Plumbing Board Request for Interpretation

NAME OF SUBMITTER Minnesota PHCC	Rule(s) to be interpreted (e.g., 4714.0330) 706, 3 & 4
--	--

Code/Rule to be interpreted: 706.3 & 4	Name of DLI employee gave interpretation: DOLI Staff	Date interpretation originally requested: July 10, 2024 Resubmitted 10/4/2024
--	--	---

CHARLOTTE PIPE AND FOUNDRY CO.		CAST IRON
1335 SOUTH CLARKSON STREET		
CHARLOTTE, NORTH CAROLINA 28208		
TITLE: 4" NH 1/8's BD. COMP. TO 4" NH 1/4 BD.		
SCALE: 1:2.5	DR BY: D.E.E.	DWG #:
DATE: 7/19/2024	PART #:	SHEET: 1 OF 1

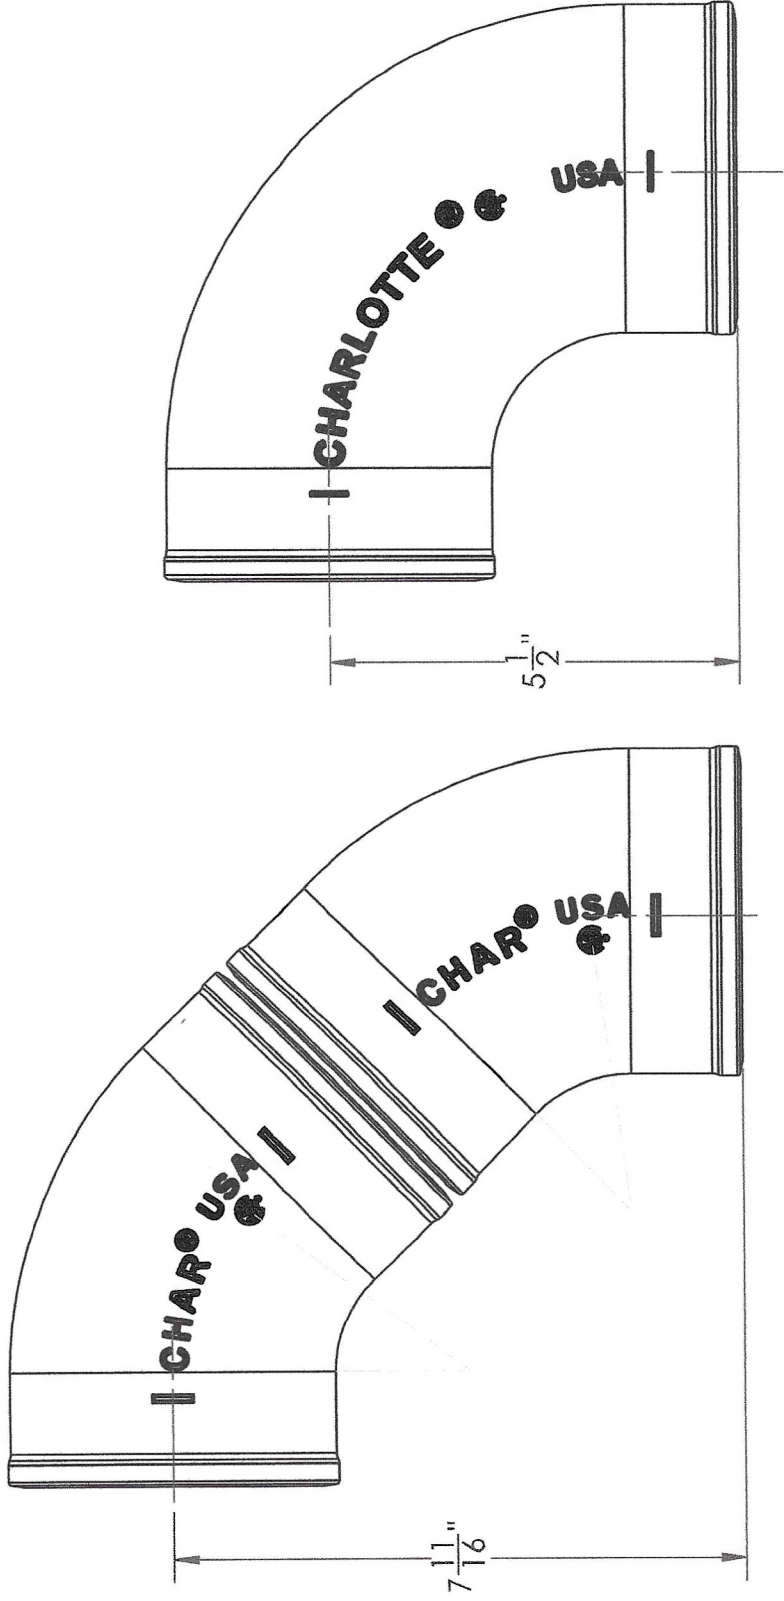
Comment #2: 706.5 Cast Iron short sweep 1/4 bends are available up and including 15", and plastic up to 6" and after that only 1/4 bends are listed. The question always boils down to what is equivalent to a combo wye and 1/8th bend, is it the radius at the back of the 1/4 bend or the end to center dimension of the combo?

1. No, horizontal to horizontal as per 706.3. "Connecting with other horizontal drainage lines shall enter through 45-degree wye branches, combination wye and one-eighth bend branches or other approved fittings of equivalent sweep." Any interruption to the flow by short or abrupt changes of direction will cause turbulence and reduce the velocity of that flow.
2. Yes, if the manufacturer can confirm sweep equivalency. In most cases the call is to require the use of 2, 45 degree elbows for a 90 degree change of direction, thinking that the chapter requires a combination Wye and 1/8 bend (or 2. 45 degree changes) some will also allow the use of "Long sweep or long pattern 1/4 bends", but when the manufacture does not list product as long pattern or long sweep fittings in 6 inch or over, one must revert to the 2, 45 interpretation.
